Design Review Board

MINUTES OF A REGULAR MEETING OF THE DESIGN REVIEW BOARD OF THE TOWN OF CLARKDALE HELD ON THURSDAY, JULY 5, 2018, AT 6:30 P.M. IN THE MEN'S LOUNGE OF THE CLARK MEMORIAL CLUBHOUSE, 19 N. NINTH STREET, CLARKDALE, AZ.

- a. **PUBLIC HEARING:** Site plan and design review of a public park to be constructed on Tract F of the Crossroads at Mingus subdivision, an approximately 3.80 acre parcel located at the northwest corner of the intersection of Mescal Spur Road and Old Jerome Highway in Clarkdale. Assessor's Parcel Number is 406-26-863 and the zoning is Planned Area Development (PAD) .
- Staff Report
 - Questions to Staff
 - Comments from the applicant
 - Open Public Hearing
 - Close Public Hearing

- c. **DISCUSSION/POSSIBLE ACTION:** regarding an application for design review of the proposed Bodega Pierce Tasting Room & Winery, located at 1341 State Route 89A, parcel #406-26-010H.

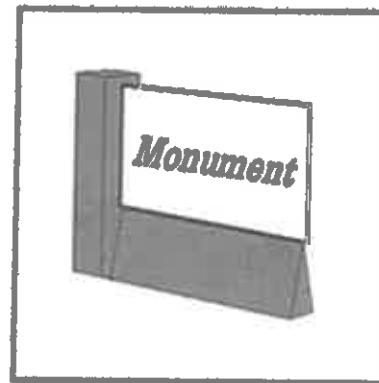
- Board Member Snyder asked what the hours would be. Mr. Pierce stated they are not yet determined, but will probably be Thursdays through Saturdays from Noon to 6 or 7 p.m.
- Chair Jones stated the font would be hard to read and suggested the applicant use a heavier typeface.
- Mr. Pierce stated the sign reflects their logo which is already in use.
- Board Member Prudhomme-Bauer suggested painting the monument sign base a darker color to prevent the sign from melting into the groundcover.
- Mr. Pierce stated they will be considering ways to increase visibility from the highway in the future.

Board Action: Board Member Prudhomme-Bauer moved to approve DRB #092082 for Bodega Pierce Tasting Room & Winery with the recommendation the applicant consider a bolder font for the sign text and a darker color for the monument base. Board Member Midkiff seconded the motion. The motion passed unanimously.
